SUNDRY NOTICES AND REPORTS ON WELLS

Proposed Procedures: LWDU # 10- Squeeze cement to surface and recomplete to 4900' and 4950' zone

# Lusk West Delaware Unit 010 30-025-21488 Shackelford Oil Company Conditions of Approval

# Permanent Abandonment of Production Zone Conditions of Approval

# Last Updated: 6/23/2015 01:36 PM

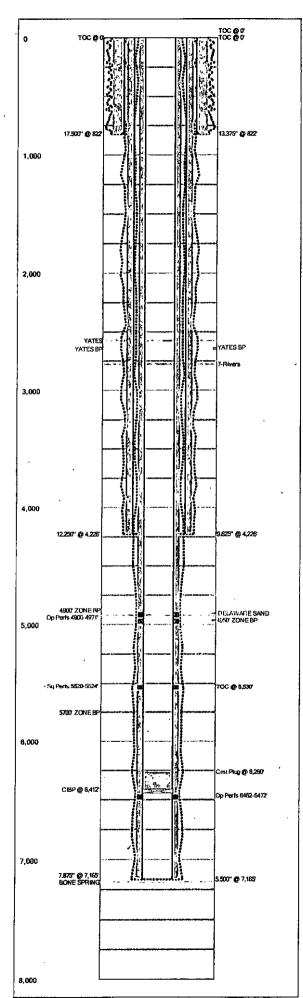
- 1. Operator approved to set a CIBP at 6412-feet and spot 25-sxs of cement. Tagged is to be witnessed by BLM.
- 2. Must conduct a casing integrity test before perforating and fracturing. Test should be run for 30 minutes. Submit results to BLM. The CIT is to be performed on the production casing to max treating pressure. Notify BLM if test fails. Document the pressure test on a one hour full rotation calibrated recorder chart registering within 25 to 85 per cent of its full range. Greater than 10% pressure leakoff will be viewed as a failed tested. Less than 10% pressure leakoff will be evaluated site specifically and may restrict injection approval.

- 3. Approved to perforate the proposed interval starting at 5520-feet as well as squeeze cement to obtain circulation to surface.
- 4. Provide BLM with an electronic copy (Adobe Acrobat Document) of the Cement Bond Log (CBL) record that will be run as proposed in Step #4 of the submitted Sundry. This electronic copy must be submitted before perforating the Delaware (Step #6). The address that may be use is pswartz@blm.gov. For additional questions on this request, the CFO BLM on call engineer may be reached at 575-706-2779.

- 5. Approved to perforate the Upper Cherry Canyon as proposed.
- 6. If successful by indication of swab test, request removal from Unit and change well name by sending in Subsequent reports and updated Completion report.

- 7. If not successful, approved to set CIBP at 4850-feet and spot 25-sxs of cement. Must be tagged which shall be witnessed by BLM. Then test the Yates as proposed. Still send Subsequent reports and updated Completion report afterwards to request removal from Unit and change well name.
